On-Island Capacity for Security of Supply

Oral submission to the Island Regulatory and Appeals Commission

Docket UE20742 · August 2026

The highest-scoring resource was left out of every option.

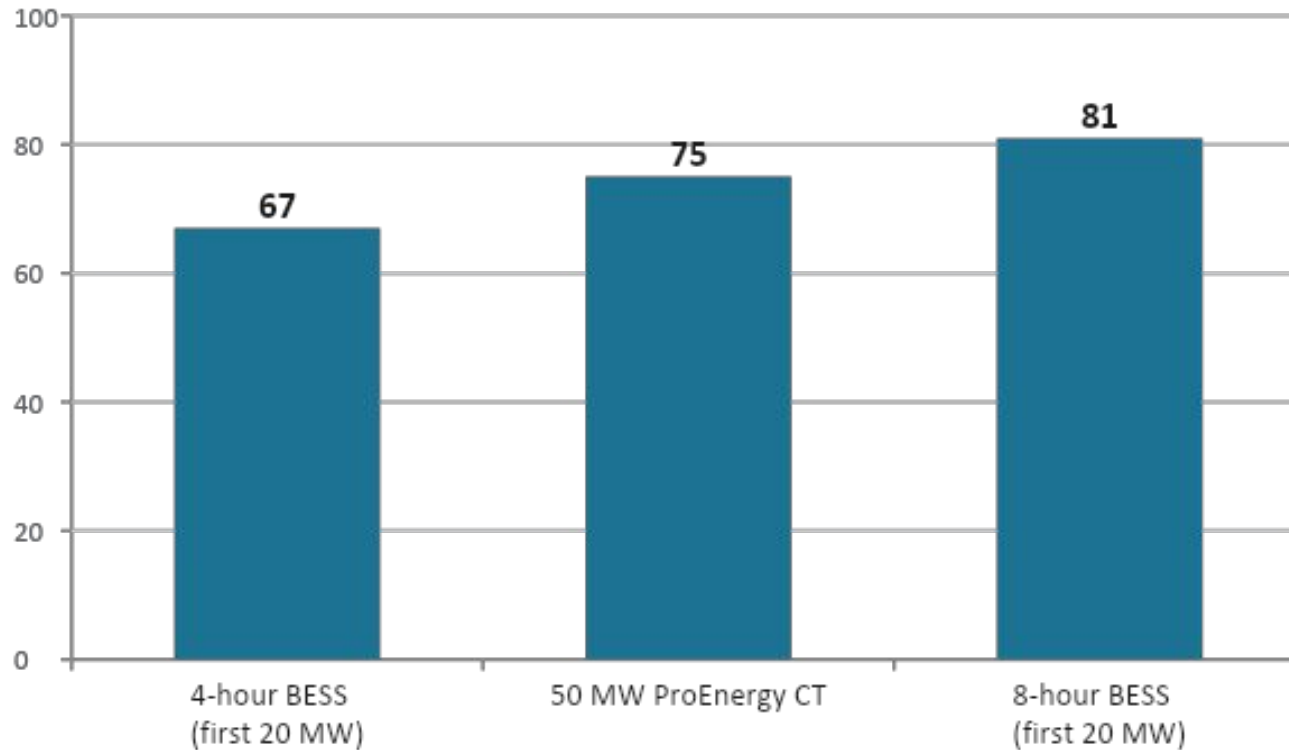
95%

Demand response

6-hour call duration, 12 calls per year (E3 Table 5-3)

86%

20 MW RICE engine

Smaller units contribute more reliably per MW

75%

50 MW ProEnergy CT

The resource this application proposes to buy

Of E3's ten candidate portfolios, none includes incremental demand response, wind, solar, interruptible load or imports — because, E3 confirmed on 17 August, “Maritime Electric did not request” them (IR-1c).

Thermal makeup of all ten portfolios “determined by Maritime Electric”; E3 sized the batteries (IR-1b). · PEIEC's demand-side management plan expired 28 February 2026 with no successor filed.

E3's own reasoning is an argument for modularity.

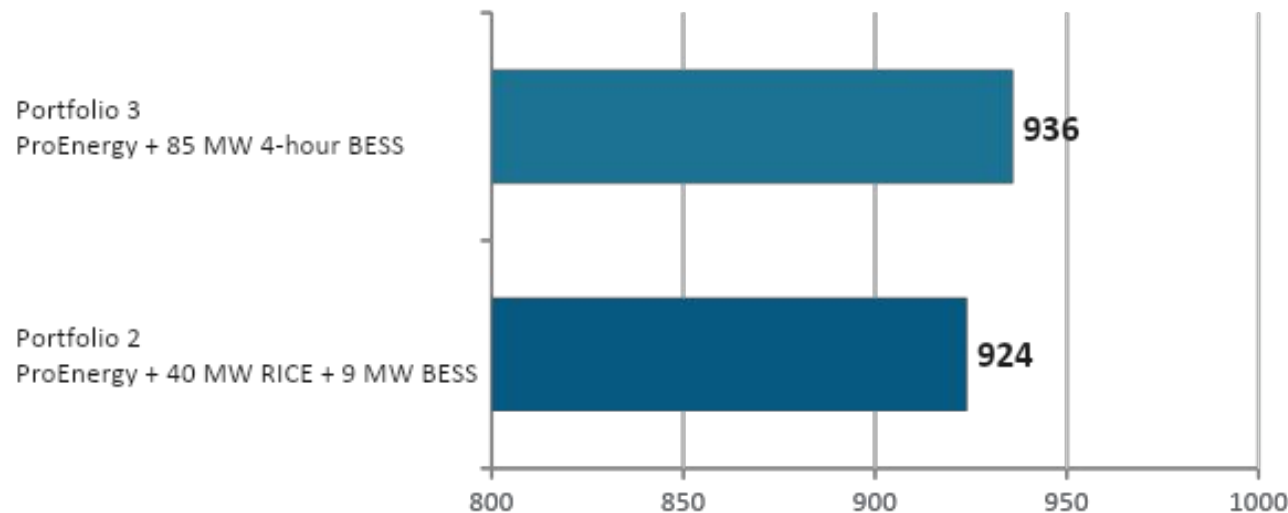
“A single large outage on a relatively small system is itself a significant driver of reliability risk.”

E3 Resource Adequacy Study, Executive Summary — the reason a 20 MW unit is accredited at 86% and a 50 MW unit at 75%.

What the proposal does with that finding

- Two identical 50 MW machines which are larger and are in a lower-accredited size
- One vendor, one production line, one site, shared fuel handling
- No PE6000 unit operating in a climate directly comparable to PEI (Exhibit C-28, IR-75)
- Pre-delivery testing at Sedalia withdrawn; units now tested on-Island, after installation (IR-74)

EPRI identifies common-mode failure as one of the risks conventional resource-adequacy modelling under-captures.

The answers arrived on 17 August.

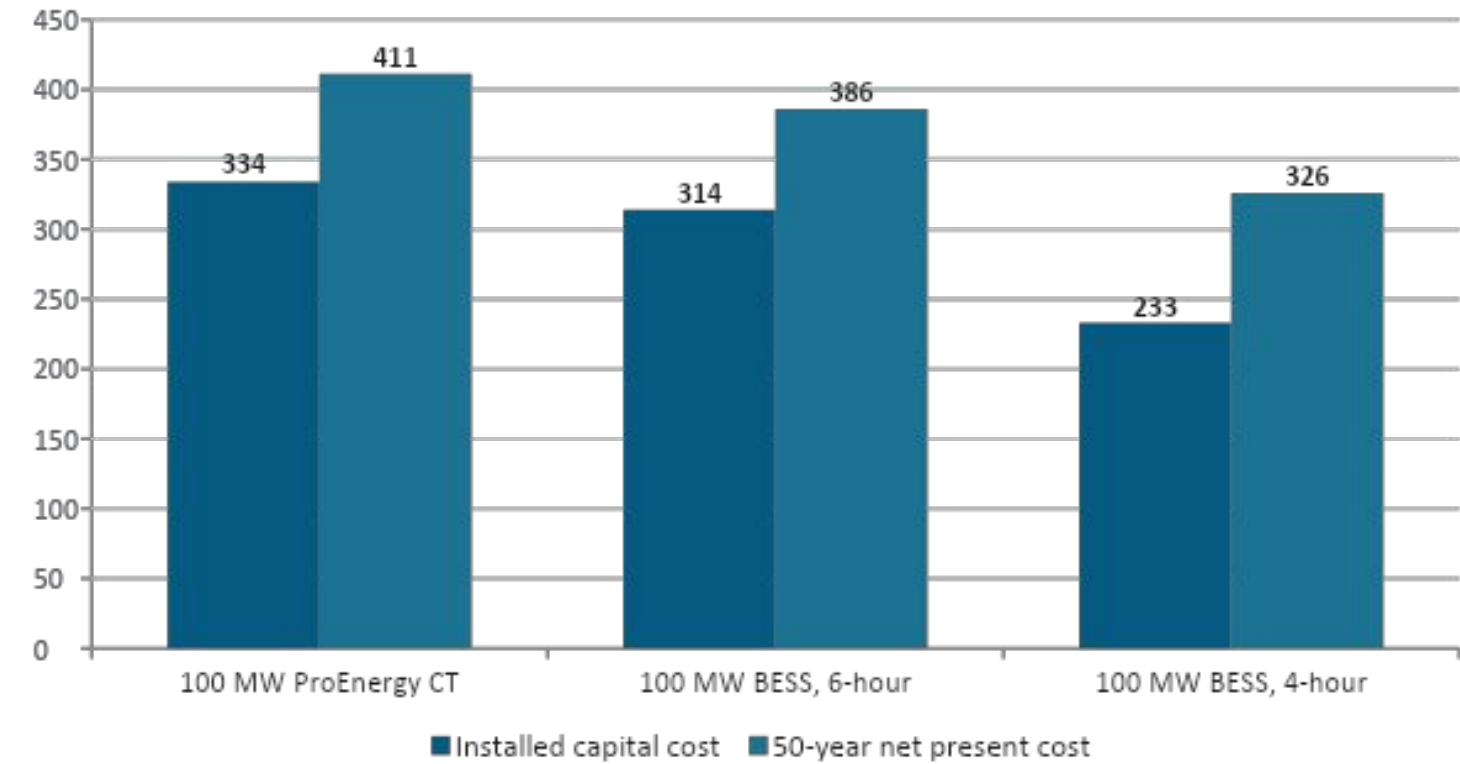
24 July 2026

E3 Study and Portfolio NPV Study filed — 19 months into the proceeding, after the Commission's expert had reported.

7 August 2026

Synapse files 14 interrogatories on the two studies (Exhibit C-33).

17 August 2026

Answers. Asked whether MECL's recommended portfolios are most cost-effective, E3 declines to say — it “did not prepare an economic analysis” and points back to MECL's own study (IR-1g).

- E3's own p. 12 recommendation, now answered: “Confirmed. E3 did not prepare an economic analysis.” (IR-1a)
- All ten portfolios “determined by Maritime Electric”; renewables, DR, imports “not requested” (IR-1b, 1c)
- Modelling limited to calendar year 2030; no LOLE analysis for any of the ten portfolios (IR-1e, 2e)
- Workpapers arrived 17 August, unexamined; the 6-hour BESS Synapse recommended never modelled (IR-2d, 8b)
- Calibration confirmed: the two proposed CTs, plus 40 MW of perfect capacity, in the base system (IR-2a)

IRAC's own expert's comparison.

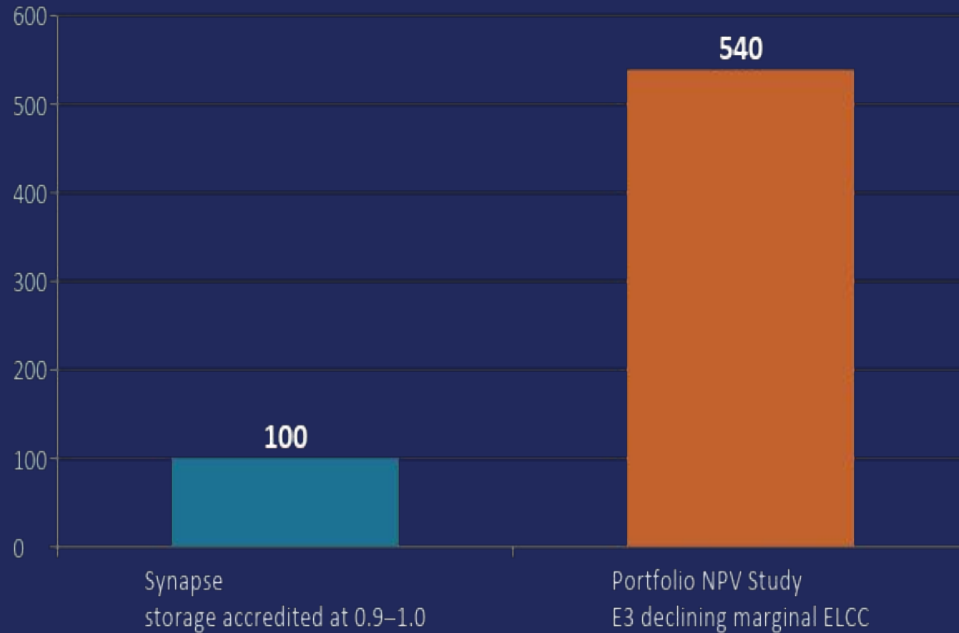
Synapse, on MECL's own accounting framework

Either battery configuration is less expensive than the turbine proposal on a net present cost basis over equivalent useful lives.

4-hour NPC ranges \$292M–\$375M depending on augmentation and replacement assumptions; \$326M shown.

The only like-for-like comparison of the actual proposal against an actual alternative anywhere in this record.

Source: Synapse Final Report (9 April 2026), Conclusions, pp. 59–60; installed cost of ProEnergy project as filed at that date (\$334M; now \$353M).

The cost gap is produced by quantity, not by price.

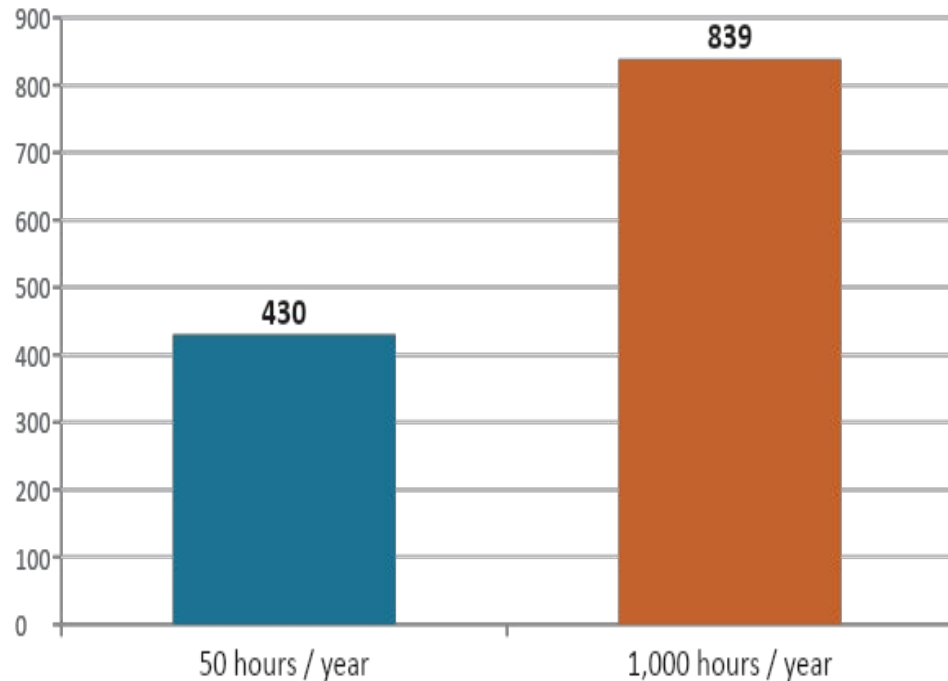
Same technology. Same unit cost. Five times the quantity.

The resulting portfolio prices

Portfolio 4 — 50 MW CT + 300 MW BESS: \$1.474B

Portfolio 5 — 540 MW BESS: \$1.852B

Not a finding about the price of batteries, but an output of the accreditation assumption. And at unchanged unit cost: BESS was modelled on a 50 MW project and scaled with quantity, so 540 MW carries 50 MW economics with no volume discount.

For a resource running 263 hours a year, capacity cost is the metric.

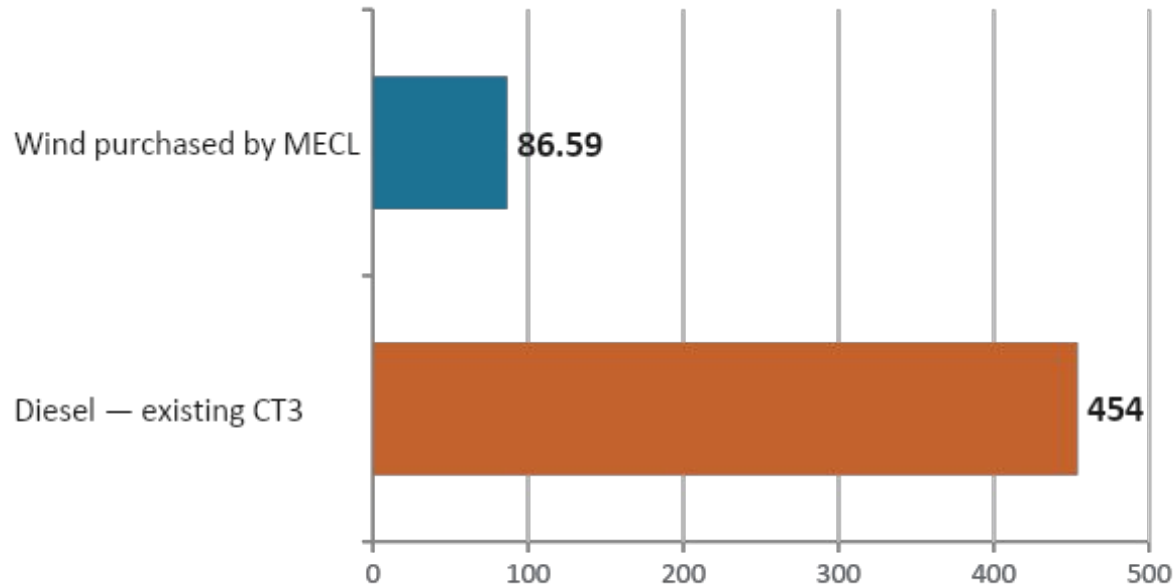
Levelized cost of capacity — the annual cost, per kilowatt of accredited capacity, of holding a resource available.

Why it matters here

- Puts a turbine, a battery, a demand-response program and an interruptible-load contract on one page
- Neither MECL nor Synapse has expressed the comparison on this basis
- It is the figure that tells Islanders what they are paying for insurance
- EDN filed levelised cost analysis earlier in this proceeding (Exhibits DN-5)

EDN asks that the Commission's own expert be invited to express the competing options on this basis.
